Access Compliance Report Public Rights-of-Way (Curb Ramps)

Intersection ID: 10776	Main Street: CAROL_AV	Cross Street: STATE_ST	Location: SE
ADA ID: 3CCA52B39D5E	Ramp Type: BlendTrans2	Initial Pass/Fail: Fail	Overall Compliance: No Severity Score: 8.75

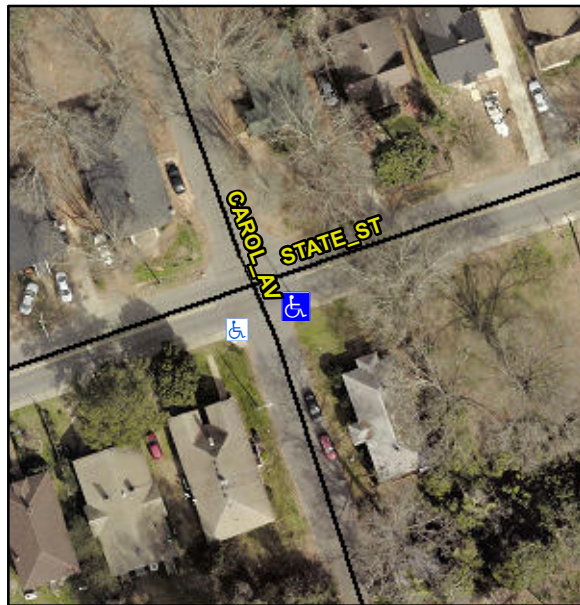
R304.5.1

Compliance	Description	Data	Compliance	Description	Data
N/A	Ramp Length (in)	88.0	Yes	BlendTrans Slope (%)	0.0
No	Ramp Width (in)	37.0	Yes	BlendTrans XSlope (%)	0.2
N/A	Flare Type LT	N/A	N/A	Flare Type RT	N/A
N/A	Flare Slope LT (%)	N/A	N/A	Flare Slope RT (%)	N/A
N/A	Flare Traversable LT?	N/A	N/A	Flare Traversable RT?	N/A
N/A	Landing Length (in)	N/A	N/A	DWS Provided?	N/A
N/A	Landing Width (in)	N/A	N/A	DWS Contrast?	N/A
N/A	Landing Slope (%)	N/A	N/A	DWS Length (in)	N/A
N/A	Landing X Slope (%)	N/A	N/A	DWS Full Width?	N/A
N/A	Landing Curb? (Y/N)	N/A	N/A	DWS Offset (in)	N/A
N/A	Shared Landing?	N/A			
N/A	Gutter Ponding?	N/A	N/A	Gutter Slope (%)	N/A
N/A	Gutter Lip Ht (in)	0.5	N/A	Gutter X Slope (%)	N/A
N/A	Painted X Walk1?	No	N/A	Painted X Walk2?	N/A
	X Walk 1 Direction	To SW		X Walk 2 Direction	N/A
	X Walk 1 Width (in)	N/A		X Walk 2 Width (in)	N/A
	X Walk 1 Slope (%)	3.7		X Walk 2 Slope (%)	N/A
	X Walk 1 X Slope (%)	7.6		X Walk 2 X Slope (%)	N/A

Remove & Replace Curb Ramp With Two New Directional Ramps or Equivalent.
